Planning and Zoning Board Agenda July 14, 2020

- A. Approval of the Minutes of the 6/9/20 PZB Meeting
- B. Site Plan – Progress Park Parcels G & H: A request by Sergio Reyes, P.E., of EDA Consultants,

Inc., applicant and agent for Ponce Inlet Investments, LLC, property owner, for consideration of a Site Plan to construct a ±12,568 square foot building with associated parking, stormwater, landscaping, and site improvements on a ±5.06 acre subject property. Tax Parcel Number 03956-010-028 (Quasi-Judicial Hearing).

Sheet No.: C010

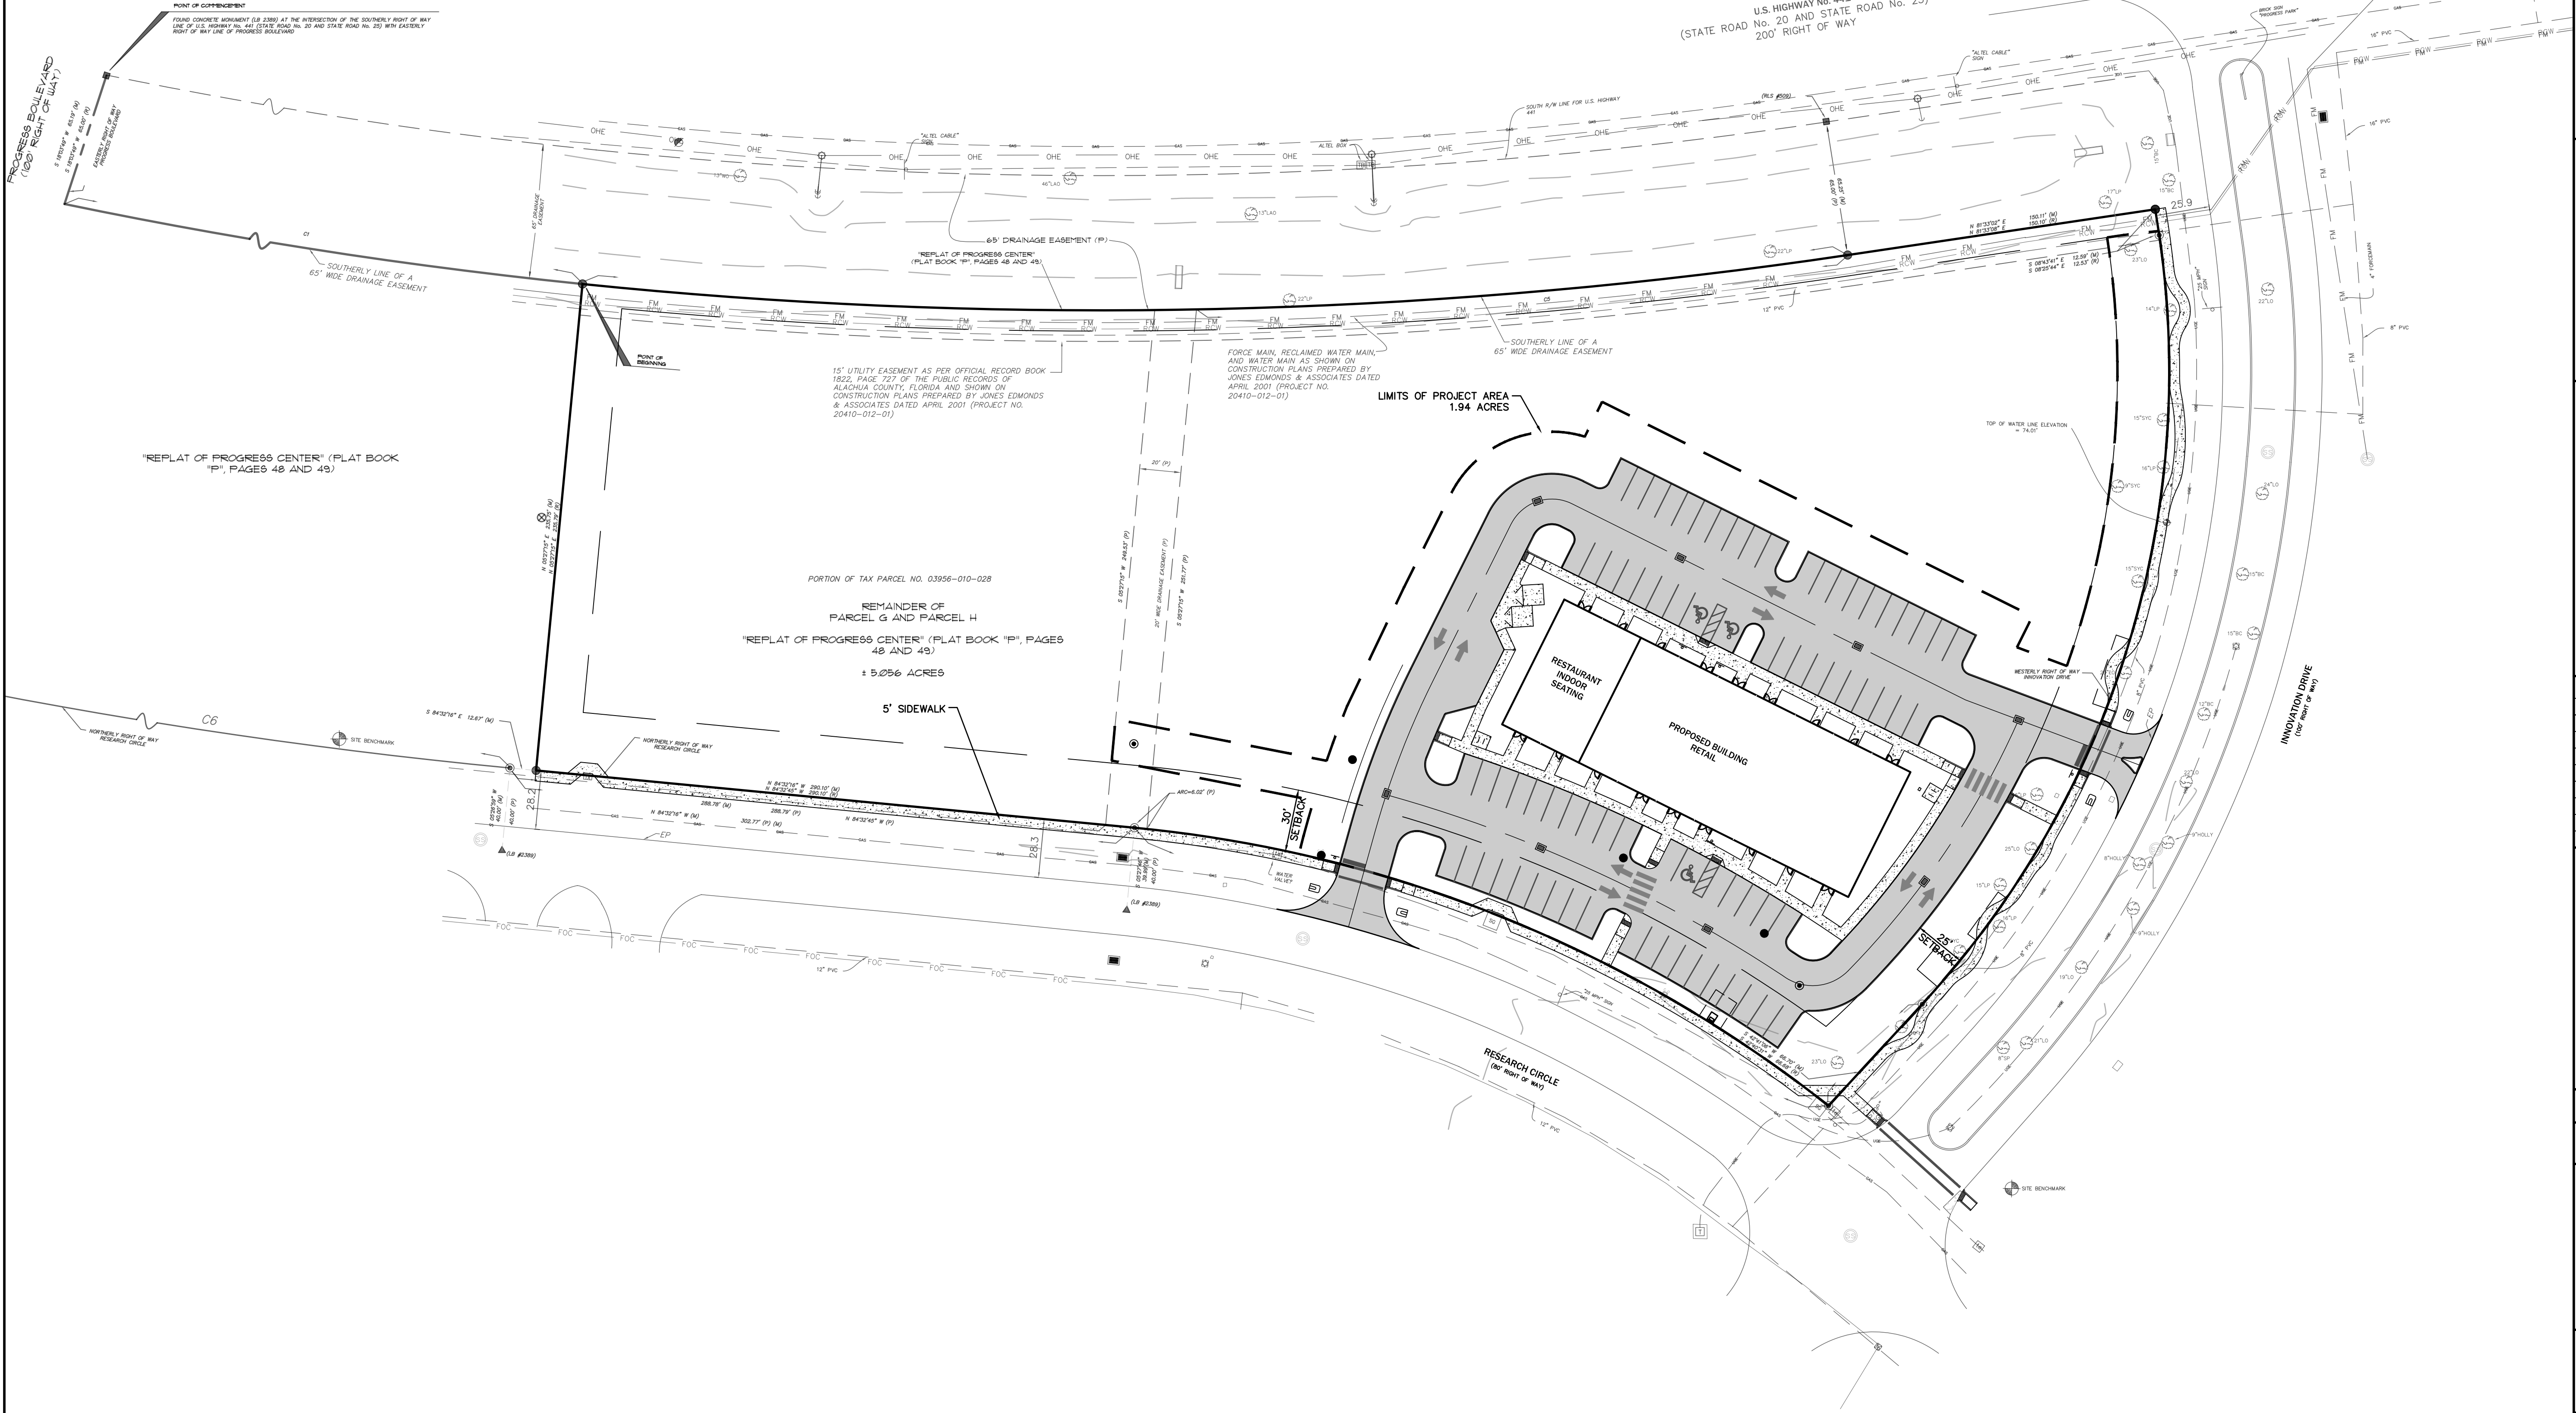
c. Sheet C010: Construction Notes, #1 – Plan is approved by the Planning & Zoning Board (PZB). Revise accordingly.

Comment on Apr 30th/May 13th Submittal Sheet C010: - Except for general note 14, there are no design notes that specify the water and wastewater systems. This is unusual. For most submitted site plans, not only are CoA standards referenced, but many notes are included specifying the water and wastewater systems. On future submittals, does the Engineer plan to include more notes that specify the water and wastewater systems? Will these be added to Sheet C010 or Sheet C410? - To Abbreviations, please add "MH = Manhole". Comment on June 2nd Submittal Approved

RESPONSE: The notes have been revised accordingly. Please see revised sheet C010.

Designed: CSV	Sheet No:
Drawn: MAB	C030
Checked: TAR	
Date: 06/22/2020

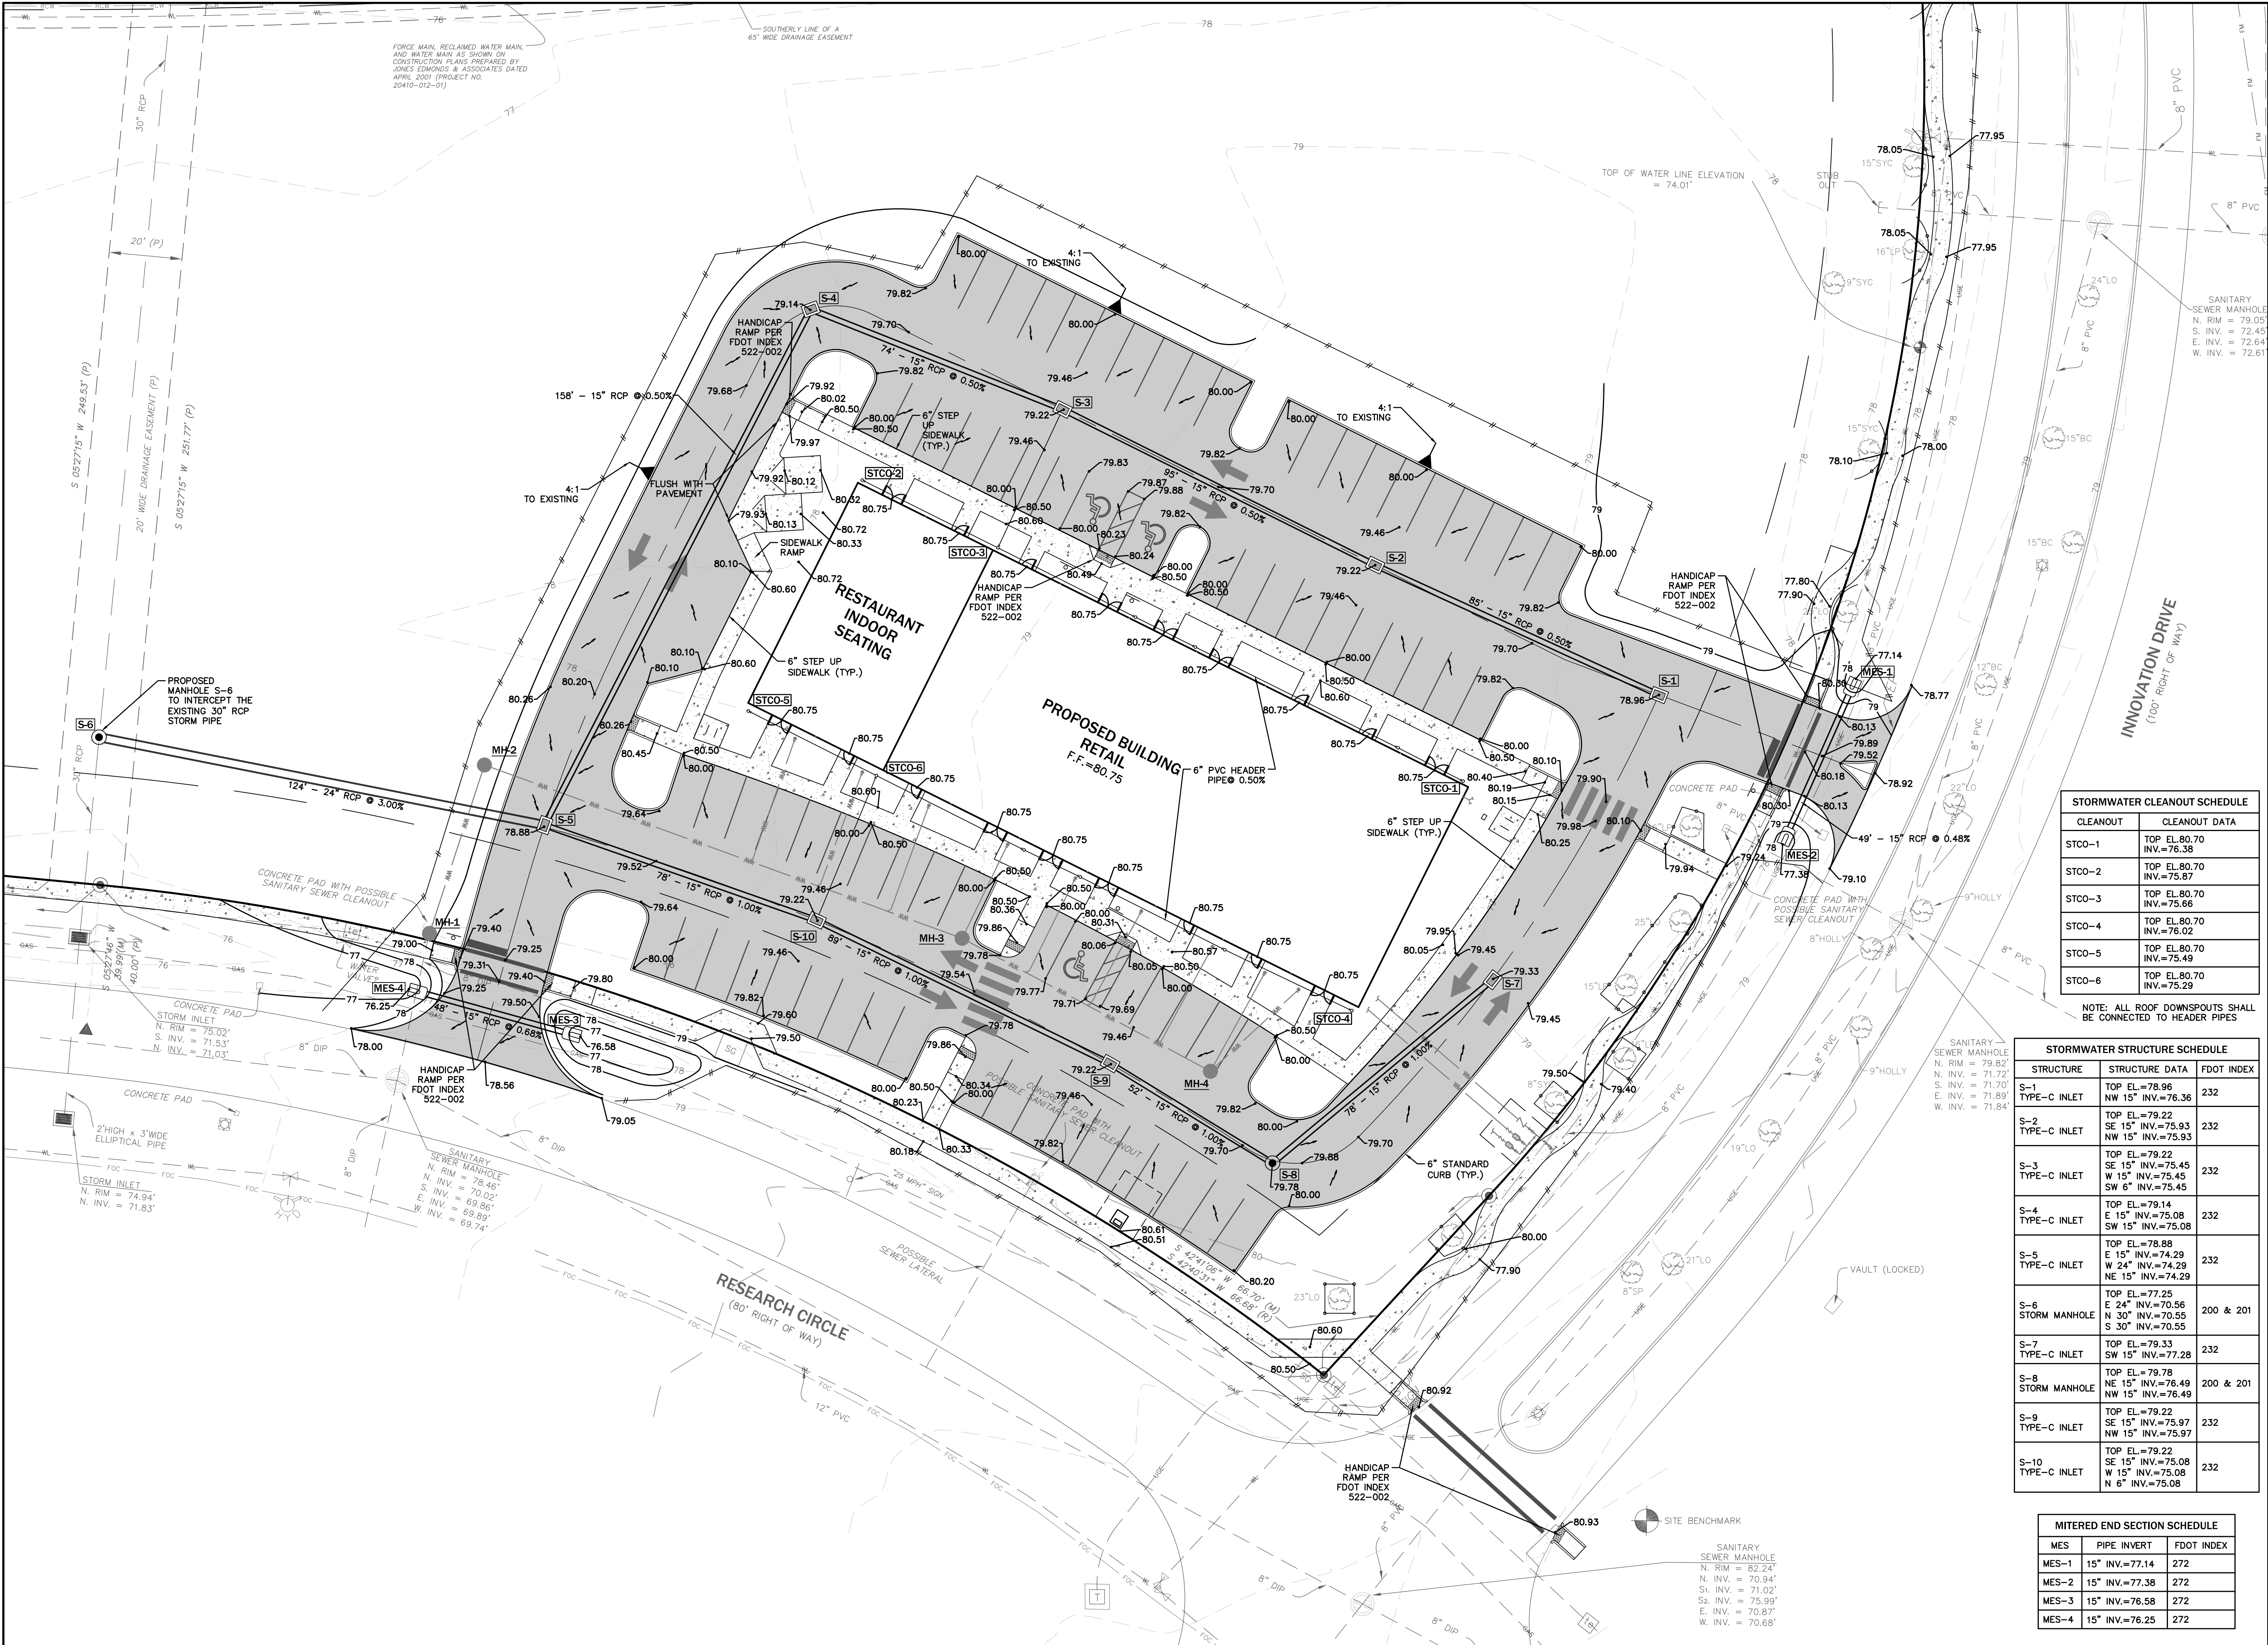
b. Label all setbacks on Sheet C030.

- c. Sheet C030: Shift the label for "Remainder of Parcel G & Parcel H" to be outside of project area and ensure the parcel number does not overlap with other drawing layers.

RESPONSE: The setbacks are now labeled in the plans. Please see sheet C030.

\\server3\engprojects\Progress Center\Parcels G & H (2019)\Plans\Current\DWG\PI\95041\DWG_C420 - UTIL DETAILS & NOTES_6/22/2020 11:23:59 AM_mbarahona

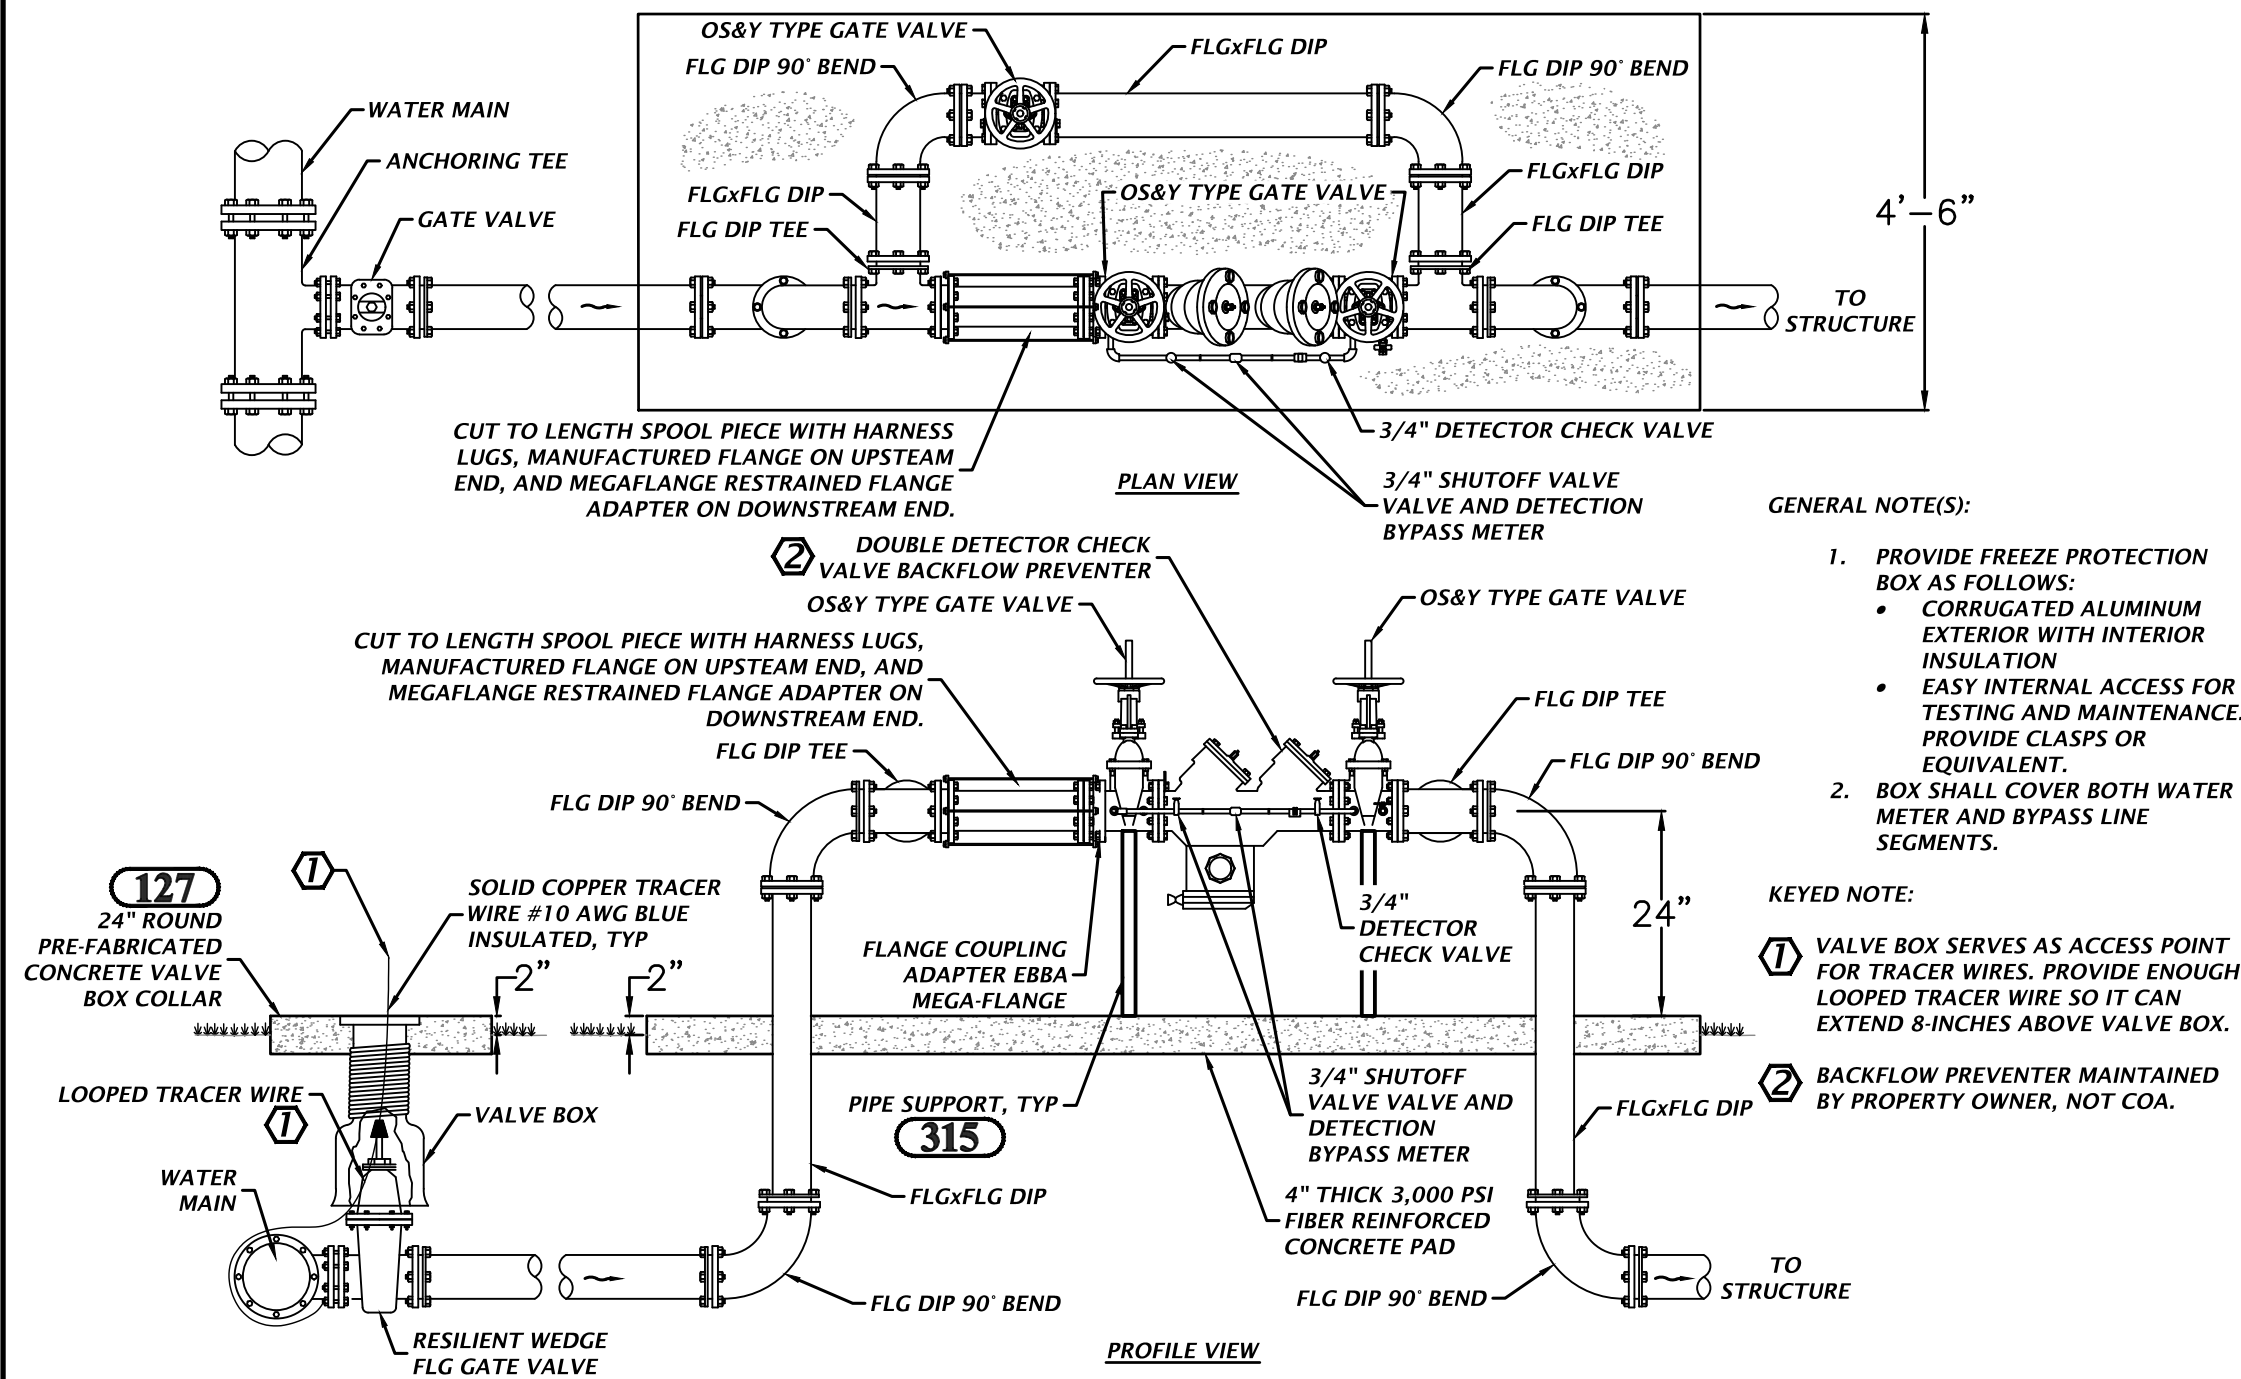
General Utility Note 7 calls out Sewer Pipe as SDR 26 PVC, but SS note 2 on Sheet C420 calls out SDR 35. Please resolve.

RESPONSE: The legend has been updated with the PUE boundary, property line, and right-of-way added. Sanitary sewer is now specified to be SDR 35 in all places. Fireline has been revised to be DIP. Please see note 14.D on sheet C210 for maintenance and repair of sidewalk within the property line.
